M170019

Comment Summary Table and Draft SE Markup

**Comment Summary for Draft Safety Evaluation for
NEDE-33005P Revision 0, “TRACG Application for Emergency Core Cooling Systems /
Loss-of-Coolant-Accident Analyses for BWR/2-6”**

Figure 2. MELLLA+ Power-to-Flow Operating Domain.

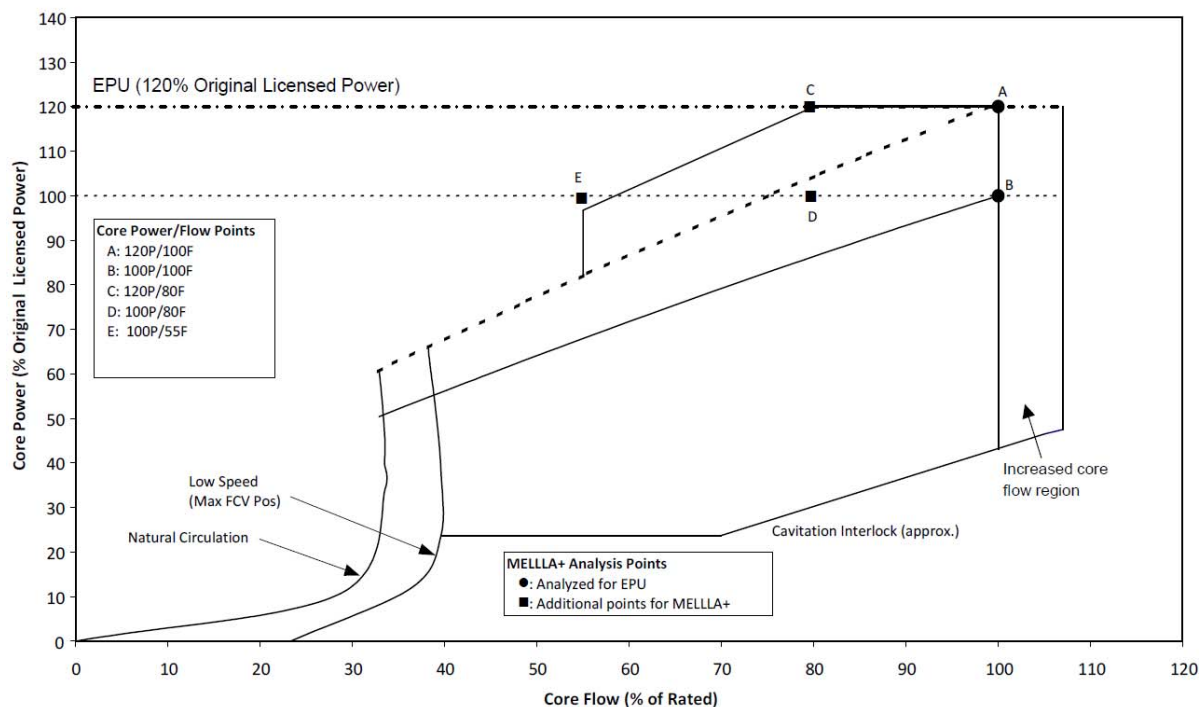
<p>Section 5.2 Operating Statepoints</p>	<p>Page 21: The figure should be cited from the MELLLA+ LTR and referred to as typical since some plant-specific maps are different.</p> <p>GEH suggests the following change (Line 5): A typical The MELLLA+ operating domain is illustrated in Figure 1-1 of Reference 58 Figure 2.</p> <p><i>Suggested change shown in the markup.</i></p>
<p>Section 5.2 Operating Statepoints</p>	<p>Page 21: The figure should be cited from the MELLLA+ LTR and referred to as typical since some plant-specific maps are different. If the figure is retained, then a better figure is needed since the figure in the SE has Points D and E misaligned.</p> <p>GEH suggests the following change (Line 7): Replace Figure 2 with Figure 1-1 from Reference 58.</p>

Location	Comment
<p>Section 5.2 Operating Statepoints</p>	<p>Page 21: If Figure 1-1 from Reference 58 replaces the existing Figure 2, then the points analyzed for MELLLA+ plants needs to be revised.</p> <p>GEH suggests the following change (Line 11): points A-B, D, and E in Figure 2. <i>Suggested change shown in the markup.</i></p> <p>Note that if the existing Figure 2 is not replaced, then the points should be A, C, and E.</p>
<p>Section 5.3 Power Distribution and Channel Groupings</p>	<p>Page 23: GEH suggests the following change (Line 29) the limiting <u>heated</u> nodes are <i>Suggested changes shown in the markup.</i></p>
<p>Section 5.3 Power Distribution and Channel Groupings</p>	<p>Page 23: Standard and hot channel are the same. Clarify the footnote.</p> <p>GEH suggests the following change to Footnote H: Note that the standard <u>channel nodalization</u>, hot channel includes [[]] axial nodes, <u>of which 25 are heated</u>. <i>Suggested changes shown in the markup.</i></p>

A typical MELLLA+ operating domain is illustrated in Figure 1-1 of Reference 58.
